SECTION 00 9302 – ADDENDUM No. 1 – FF&E

**NONNEWAUG HIGH SCHOOL**  
**5 Minortown Rd, Woodbury, CT 06798**  
**Phase 3 of 3 Furniture, Fixtures and Equipment**

**S/L/A/M Project No. 15232.00**  
**State Department of Education Project No. 214-0093 RN**

Typical end panel design for  
D03, D04, D05 and D06

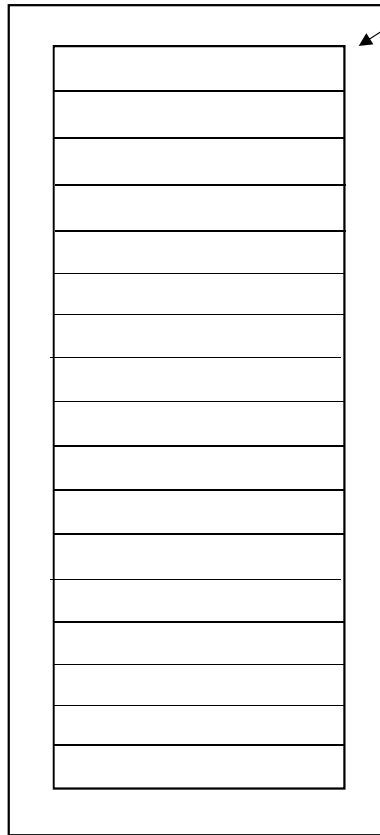
3. Page 73, Item D03, **ADD** Product Description; Slatwall to be 3” on center, 3” solid wood frame surrounding slatwall at end panels, aluminum channels for all slat openings to be included, refer to attached detail of end panel intent.

4. Page 73, Item D04, **ADD** Product Description; Slatwall to be 3” on center, 3” solid wood frame surrounding slatwall at end panels, aluminum channels for all slat openings to be included, refer to attached detail of end panel intent.

5. Page 73, Item D05, **ADD** Product Description; Slatwall to be 3” on center, 3” solid wood frame surrounding slatwall at end panels, aluminum channels for all slat openings to be included, refer to attached detail of end panel intent.

6. Page 73, Item D06, **ADD** Product Description; Slatwall to be 3” on center, 3” solid wood frame surrounding slatwall at end panels, aluminum channels for all slat openings to be included, refer to attached detail of end panel intent.

3" wood frame border around  
slatwall on end panels

3" spacing on center for slats

Aluminum channel at slat  
opening to be included

Similar to the end panel  
shown in D06 but without  
the detailing at the top
